**To:** John Tunstall  
**From:** Jeff Walton, Associate Planner; 910-341-3260  
**CC:** File; Protrak  
**Date:** 12/20/2013  
**Re:** Carolina Bay Phase II

The following is a list of comments for review from planning regarding the project. Please provide your corrections as listed below. Additional review will be required once all the needed documents have been provided. Items or documents not provided on initial submission will be subject to further review. Please contact me for any further questions.

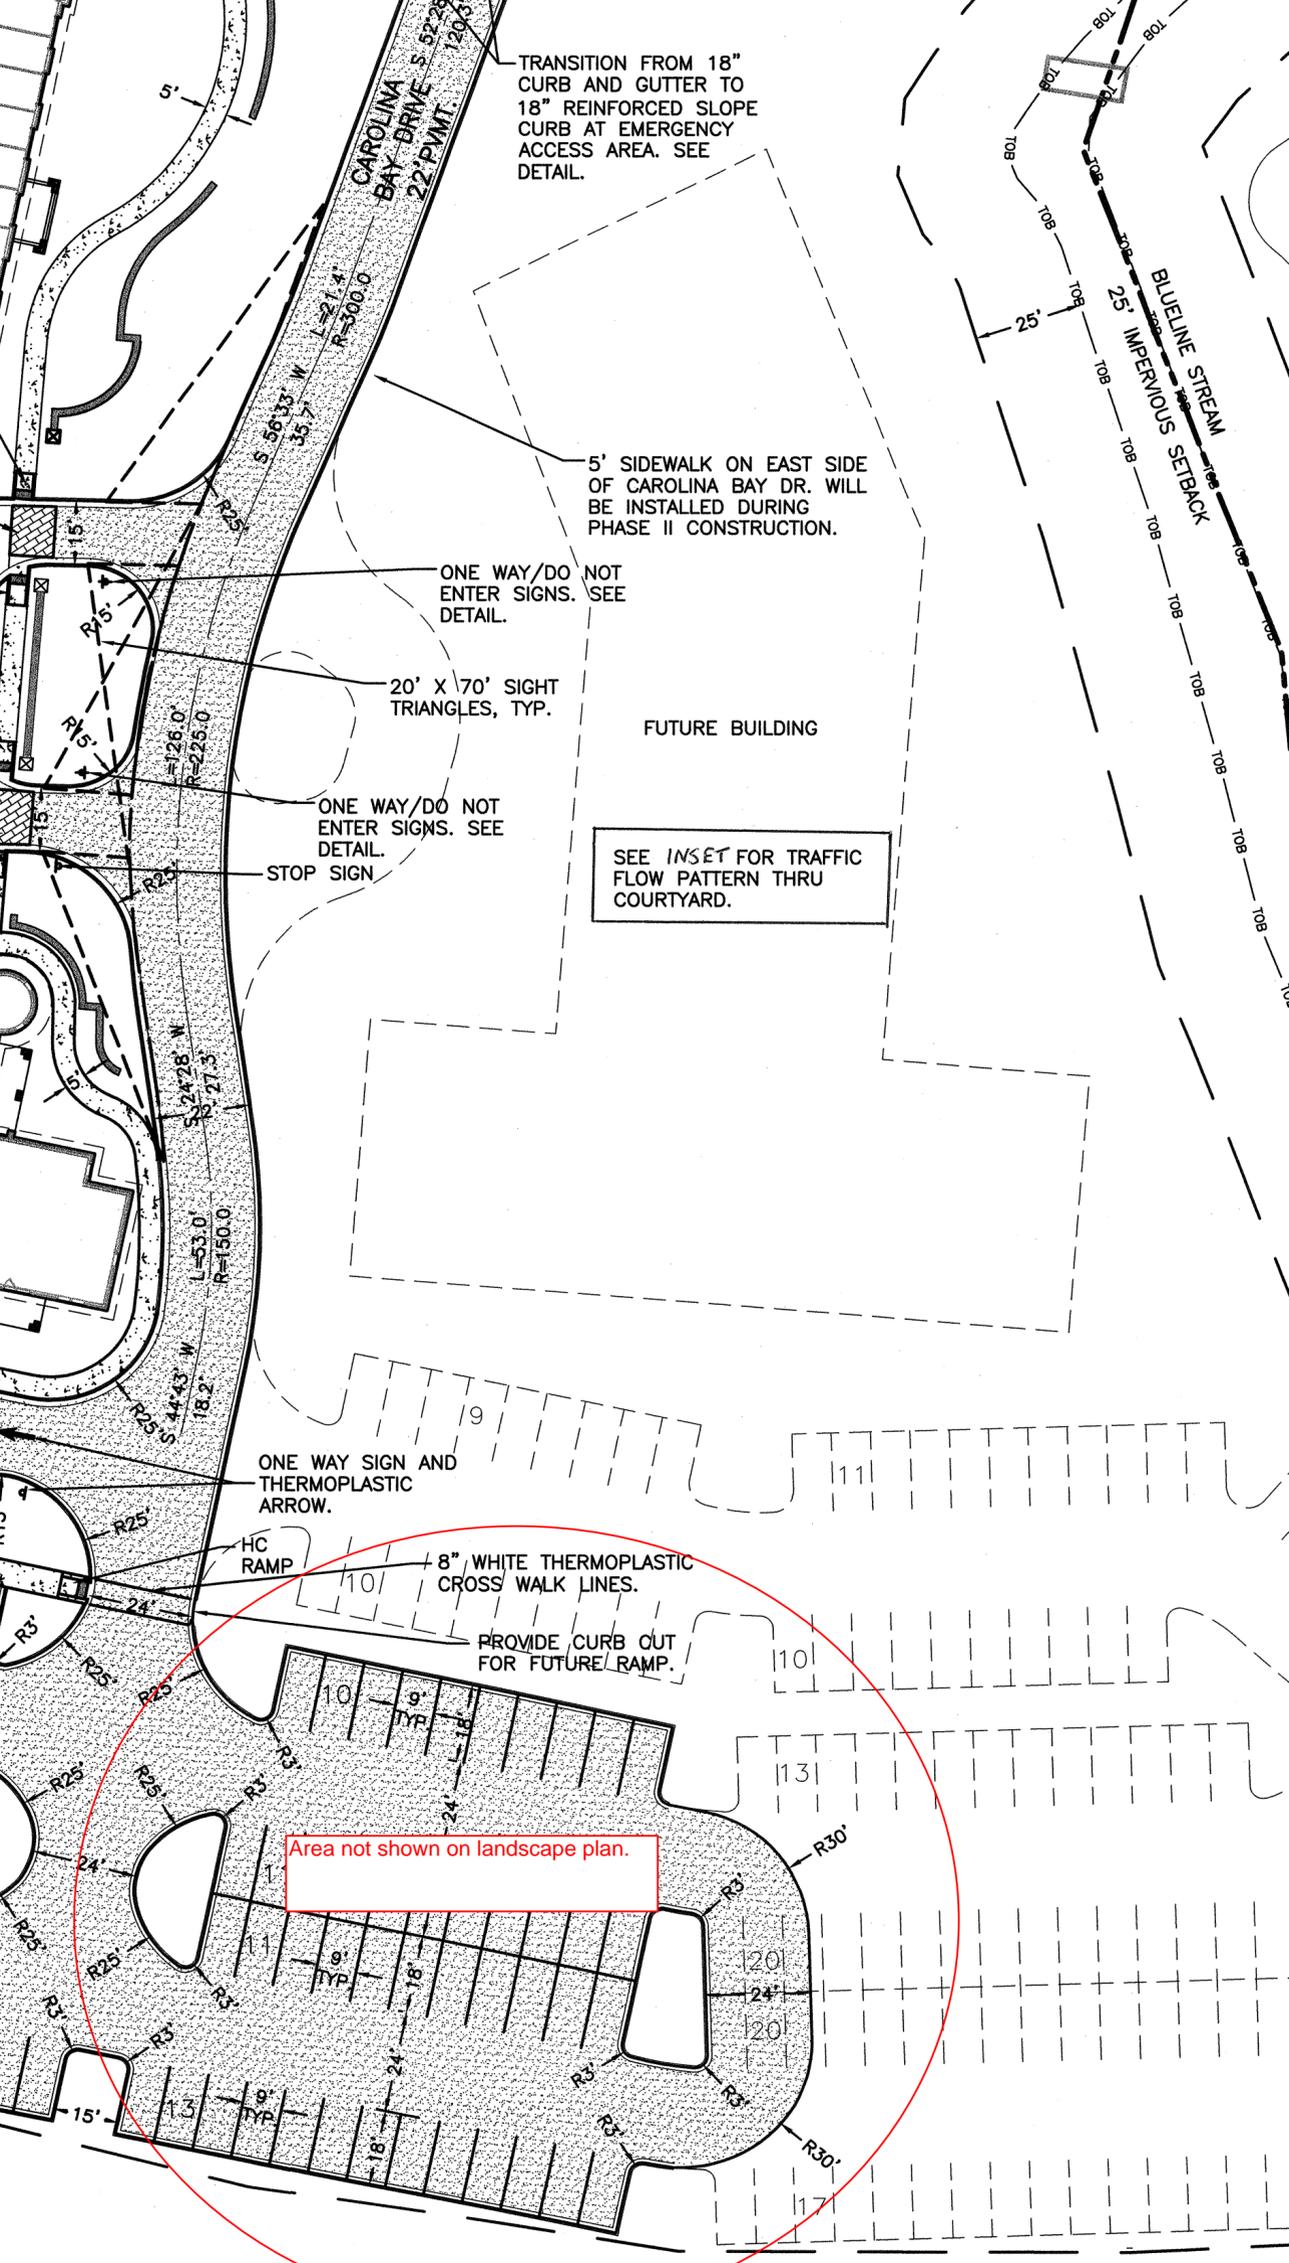
- Can you darken the preserved trees? It's hard to see them within the landscape islands.
- I have attached some redlines of questionable areas.
  - Need to add a tree to a landscape island

- Some areas of Phase II were not shown on landscape plan.

Add a tree for compliance

Area not shown on landscape plan.
